UNITED STATES PATENT AND TRADEMARK OFFICE

APPLICATION NO.	FILING DATE	FIRST NAMED INVENTOR	ATTORNEY DOCKET NO.	CONFIRMATION NO.
10/807,420	03/23/2004	Craig A. Barrile-Josephson	P03137	3853
23702	7590	03/10/2009		
Bausch & Lomb Incorporated One Bausch & Lomb Place Rochester, NY 14604-2701			EXAMINER MENDOZA, MICHAEL G	
			ART UNIT	PAPER NUMBER
			3734	
			MAIL DATE	DELIVERY MODE
			03/10/2009	PAPER

Office Action Summary

DETAILED ACTION

FIG. 2

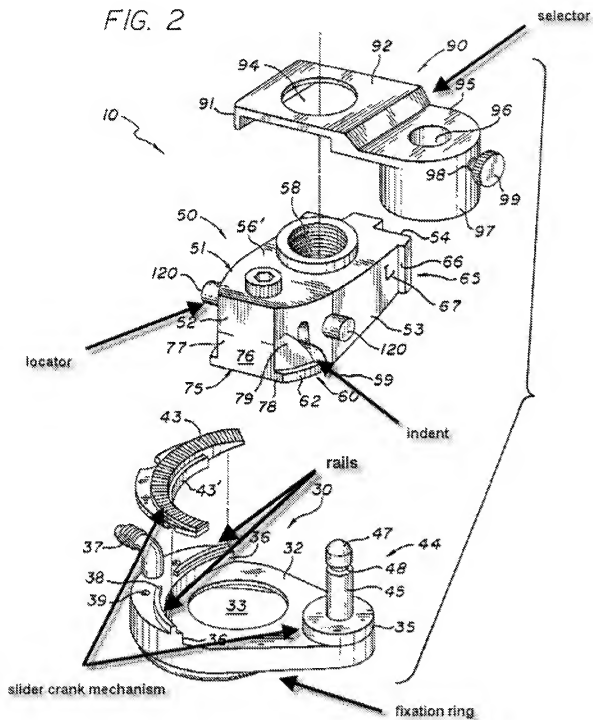
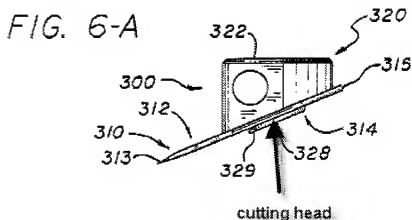
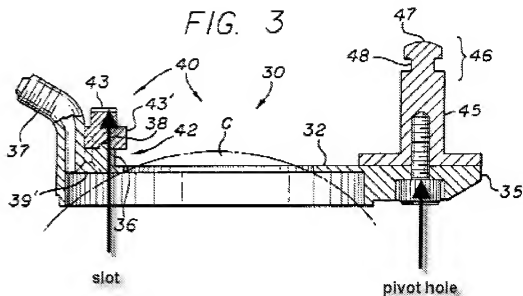
8. Hellenkamp et al. teaches a microkeratome for use in ophthalmic surgery comprising: a slider-crank mechanism (motor cranks gears to slide blade); a cutting-head; a fixation ring; wherein the slider-crank mechanism moves the cutting-head at least partially across the fixation ring; a controller (200); wherein the drive includes a left/right selector that is alternately moveable between a start position of the drive for a patient's left eye and a start position for a patient's right eye (see figs. 10a-10b); a cutting-head locator including indents; a translation stop (65); a motor (100); a passage from a bottom surface of the ring and with the ring for connection to a vacuum source (col. 7, lines 1-18); wherein the fixation ring includes structure extending beyond a bottom-most part of an annular ring and raised about the bottom-most part of the

annular ring (see figs. 3-5); wherein the slider-crank mechanism includes a pivot hole and a slot formed on the fixation ring (between each tooth of track 43 there is a slot); wherein the pivot hole and the slot are generally on opposite sides of the ring; wherein the pivot hole and the slot cause the cutting head to move in an arcuate path (see figs. 10a-10b); wherein the slider-crank mechanism includes at least two slot formed on the fixation ring and a pair of rails.
